## Determination 2019/008

# Regarding the code-compliance of a proposed pool barrier at 43 Burwood Crescent, Remuera, Auckland

**Figure 1: Site plan as April 2018 (not to scale)**

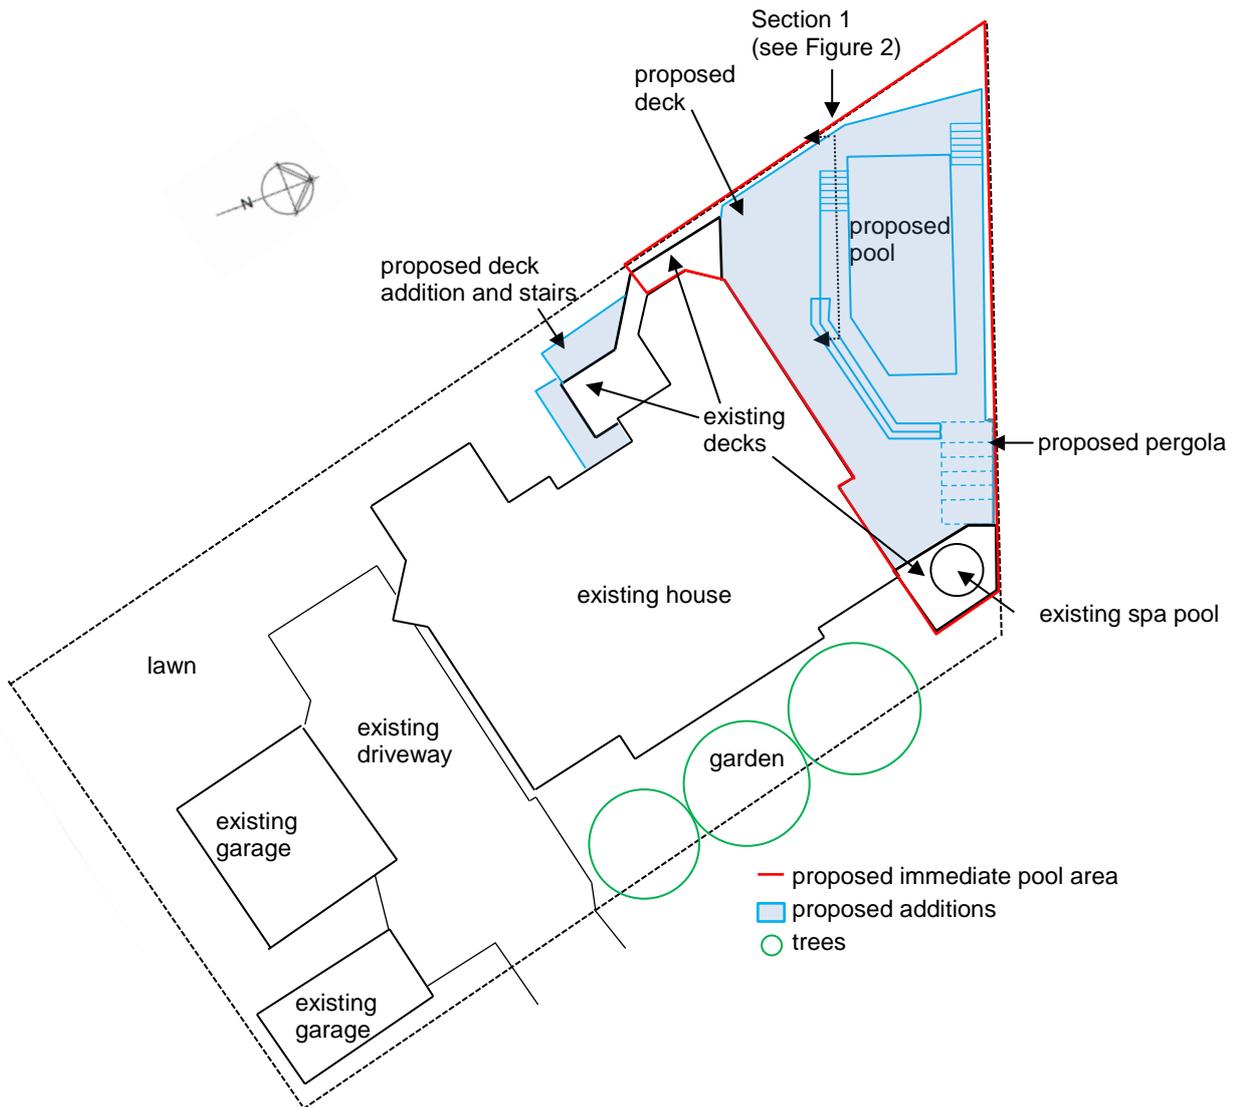
2.3 In response to the request for information, the agent submitted revised plans dated 5 April 2018 (“the April 2018 plans”). Figure 1 identifies the proposed immediate pool area. A section through the proposed decks is included in Figure 2. A simplified sketch of the April 2018 plans, showing the elements that are relevant to this determination, is included here in Figure 3.

1. With reference to the [level 3 deck], the [level 3 deck], will not have a strong enough relationship to the immediate pool area to be considered compatible with the use of the pool and the definition of immediate pool area.

As per your response outdoor furniture will be located on that deck which has more of a link to the house, ie dining and lounging than it does to the use of the pool (being that is also one deck tier higher).

You will need to exclude the Upper deck from the immediate pool area and re-design the pool barriers and gate location to suit.

**Figure 2: Section 1**

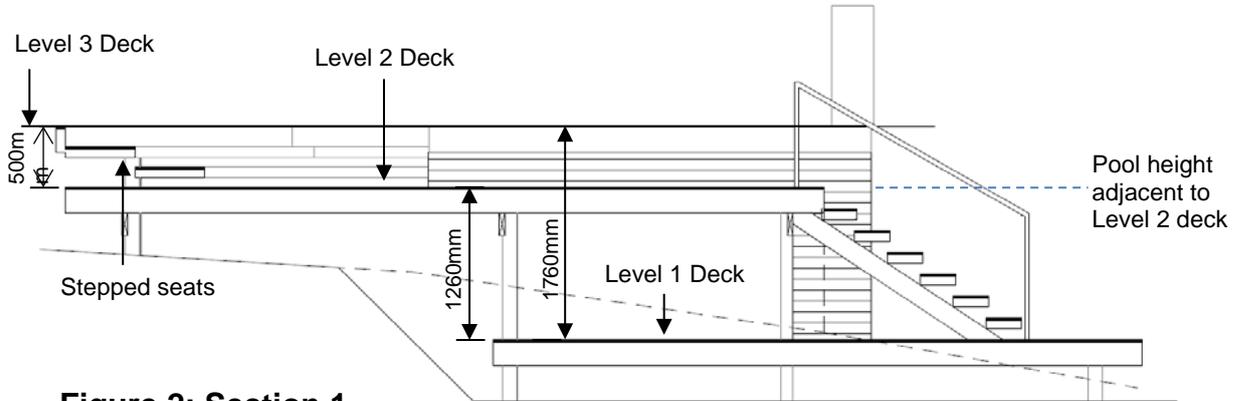
- 5.7.10 In its submission, the authority refers to Determination 2017/082 in support of its view that the level 3 deck does not constitute part of the immediate pool area, because the level 3 deck is above the level 2 deck. However, the two decks considered in Determination 2017/082 are materially different from those being proposed in the April 2018 plans. In particular, Determination 2017/082 considers a change in height at more than 2.4 metres, while the April 2018 plans show a 0.5m change in height, which I consider to be a relatively minor change in height.

- 5.7.11 The change in height is not the determining factor of whether the level 3 deck is included within the immediate pool area. I am of the view the relatively minor height difference between the level 3 and 2 decks and the proximity of the deck to the pool does not exclude the level 3 deck from the immediate pool area.

**Figure 3: Site plan sketch at April 2018 (not to scale)**

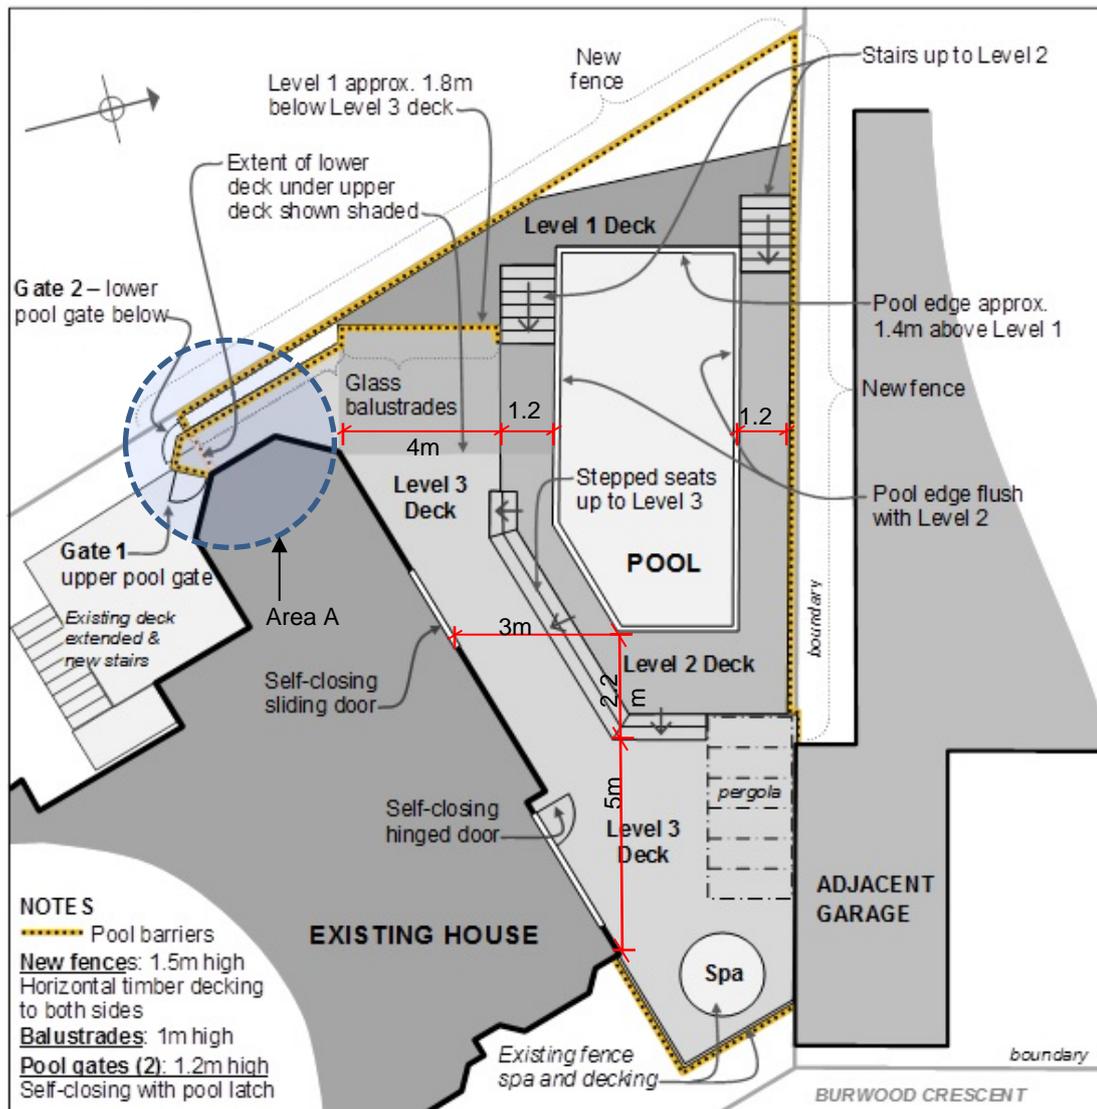
- 5.7.13 I consider Area A on the level 3 deck (refer Figure 3) to be outside the immediate pool area because it is located around the side of the building. There is an indirect association due to the deck's position in relation to the pool which means it is unlikely to be used for activities in relation to or involving the pool. The further away from the pool, the less likely the area will be used in conjunction with the pool. I accept that the remainder of the level 3 deck will be used for activities carried out in relation to the pool, such as sunbathing and dining.

- 5.7.14 Therefore, I conclude the level 3 deck, excluding Area A, can be included within the immediate pool area because of its proximity to the pool and the activities likely to occur within the area.

- Area A on the level 3 deck, see Figure 3
- the areas surrounding the level 1 deck, see Figure 5.

- 6.1 In accordance with section 188 of the Building Act 2004, I hereby determine the 5 April 2018 plans for the pool, decks, and pool barrier do not comply with Clause F9 – Means of restricting access to residential pools of the Building Code.

**Figure 4: Site plan sketch at June 2018 (not to scale)**

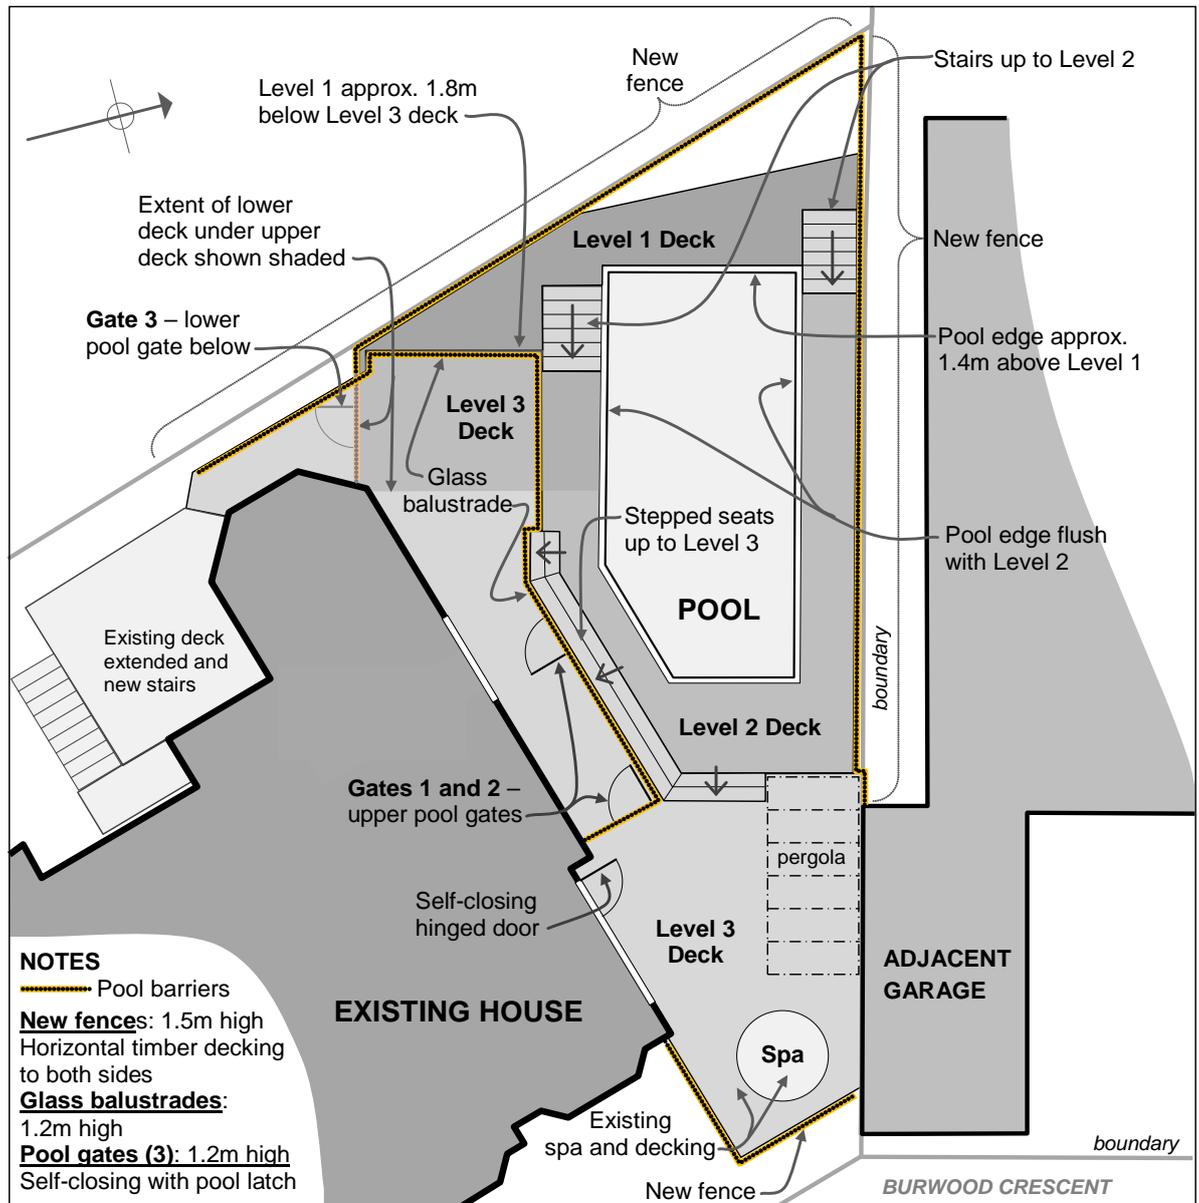
2.15 The agent then submitted two sets of revised plans. The second of these, dated 5 June 2018 ("the June 2018 plans"), show a portion (around half) of the level 3 deck now excluded from the immediate pool area by a glass pool barrier. These barriers are now stated to be 1.2m high and extend around the perimeter of the western portion of the level 3 deck, at the top of the stepped seats. At the eastern end of the seats the barrier turns in to join the house. A self-closing self-latching pool gate has been added to the barrier at this location, to enable access between the excluded area of the level 3 deck, and the portion that is still enclosed within the immediate pool area, namely the area where the spa pool and pergola are located.

**Figure 5: Level 1 deck plan (not to scale)**

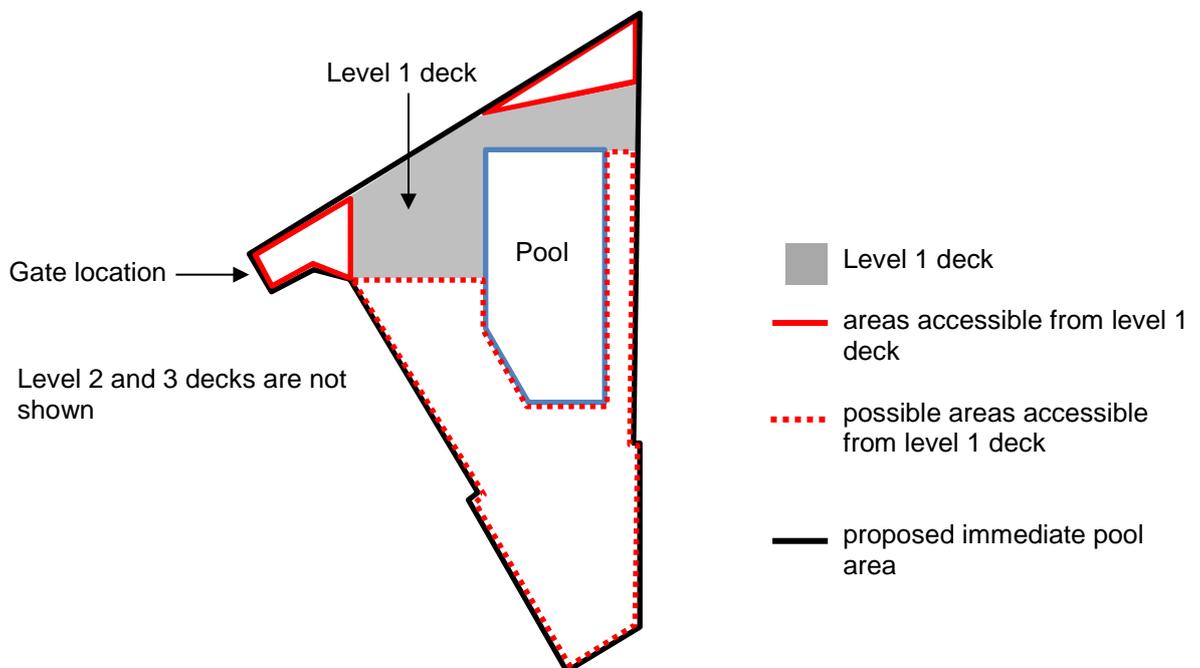
- 5.7.15 The level 1 deck is proposed for the storage of pool equipment, which is an activity that can be included within the immediate pool area. However, there are areas around the level 1 deck that I consider are outside of the immediate pool area. I have not seen any evidence these areas, highlighted in red in Figure 5 (it is not clear whether the dashed area is accessible from the level 1 deck), are directly associated with the pool and it is unlikely any activities occurring in these areas will involve the use of the pool. I note most of these areas are located underneath the level 2 and 3 deck.
